Access Compliance Report Public Rights-of-Way (Curb Ramps)

Main Street: ANTONIO_PKWY		Cross Street: N/A		Location:	SE
ADA ID: RPRK211202130036	Ramp Type: Type 4 - Parallel	Initial Pass/Fail: Fail	Overall Compliance: No	Severity Score:	16
Codes/Mitigation Info/Possible Solution			Field Measurements/Component Compliance

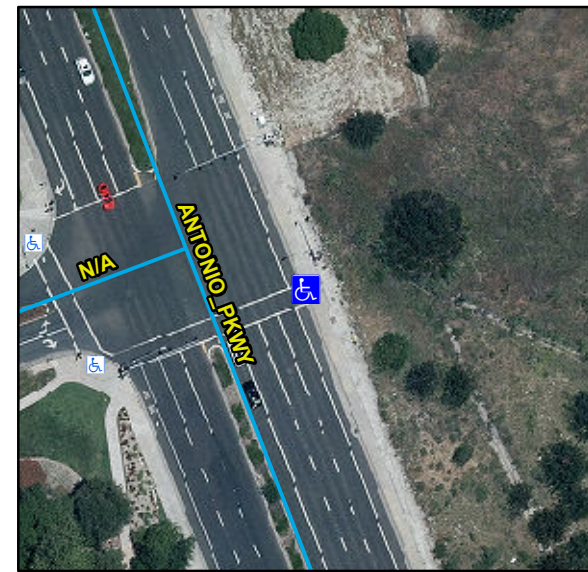
Compliance	Description	Data	Compliance	Description	Data
N/A	Ramp Length LT (in)	120	N/A	Ramp Length RT (in)	136
Yes	Ramp Width LT (in)	101	Yes	Ramp Width RT (in)	101
No	Ramp Run Slope LT (%)	9.5	Yes	Ramp Run Slope RT (%)	2.5
No	Ramp Cross Slope LT (%)	2.5	Yes	Ramp Cross Slope RT (%)	0.5
N/A	Landing Present	N/A	N/A	DWS Provided	N/A
N/A	Landing Length (in)	N/A	N/A	DWS Contrast	N/A
N/A	Landing Width (in)	N/A	N/A	DWS Length (in)	N/A
N/A	Landing Run Slope (%)	N/A	N/A	DWS Full Width	N/A
N/A	Landing Cross Slope (%)	N/A		DWS Offset Type	N/A
N/A	Landing Movement Obstructed?	N/A	N/A	DWS Offset Left (in)	N/A
	Landing Movement Type	N/A	N/A	DWS Offset Right (in)	N/A
N/A	Landing Shared	N/A			
N/A	Clear Space	N/A			
N/A	Clear Space To Crosswalk (in)	N/A			
N/A	Marked Crosswalk 1	Yes	N/A	Marked Crosswalk 2	N/A
	Crossing 1 Direction	W		Crossing 2 Direction	N/A
	Marked Crosswalk 1 Width (in)	144		Marked Crosswalk 2 Width (in)	N/A

Remove & Replace Entire Ramp.

R304.3.2, R304.5.3, STD 1115
